From: To:	
CC:	
Sent: Subject:	O8W-PM - Bucks Creek 1101 Phase 1,2&3 - Pre-Engineering Meeting

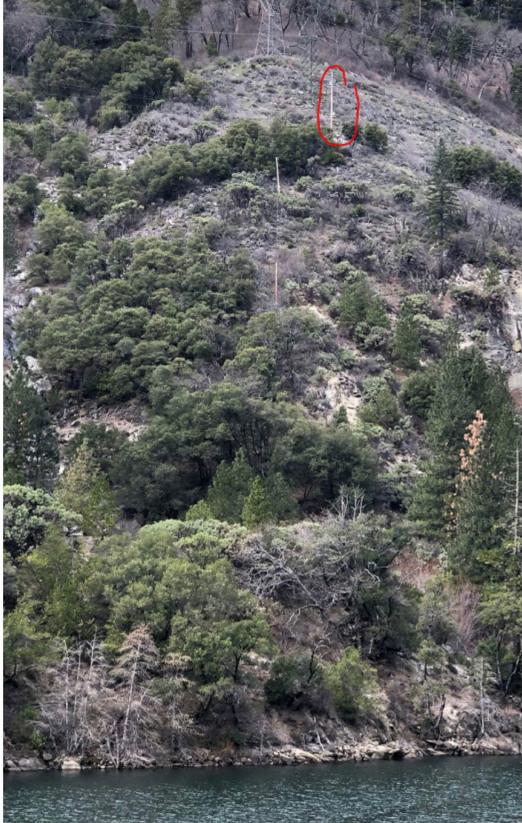
- 1. Preliminary Drawing was not provided
- 2. Trench Location:
 - a. We determined that landing the trench ~2' into the lane from the ETW (fog-line) was probably the best consistent location of which it would be ideal if the 7-boxes could be landed in the 'travel lane'. This will need to be discussed with
 - b. Any proposed poles to be placed 52' from ETW if possible, if not they will need 'gaurdrail' protection to assist with DSDD exceptions.
- 3. Rock Creek Bridge Crossing

a. Scope is not clear for this cross since it leads us to a 'what-if' scenario of, if doesn't allow the conduits to be attached to the existing bridge we should span the river OH. This will need to be discussed with to first determine 'if' we can attach the their bridge before scope is locked??

e. Here is pic:

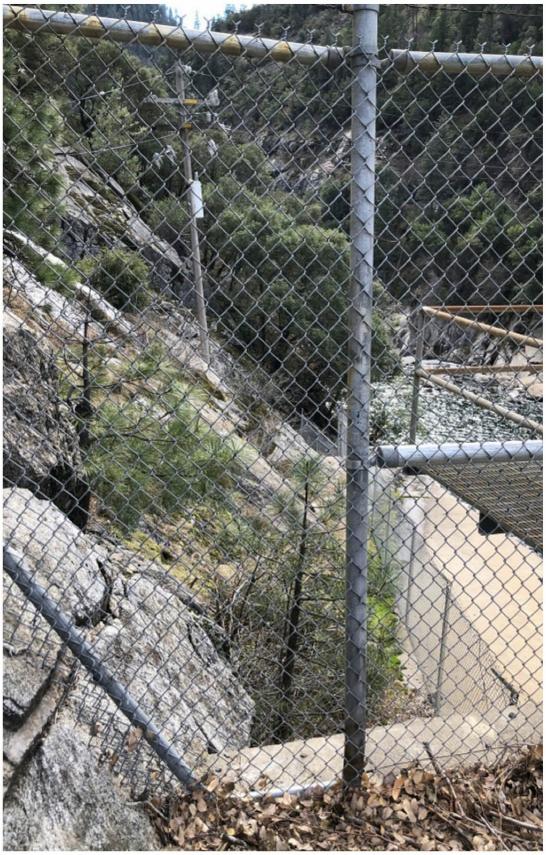
- 1. **Example 1** located in picture below also has a weather station on pole and scope for replacing this T<u>x is another</u> 'what if' scenario of:
 - a. Does the need the service?
 - b. If they do can we serve via a crossing at the Cresta Dam.
 - c. If Cresta Dam doesn't work should we cross the river a different location?
 - d. What do we do about the weather station?
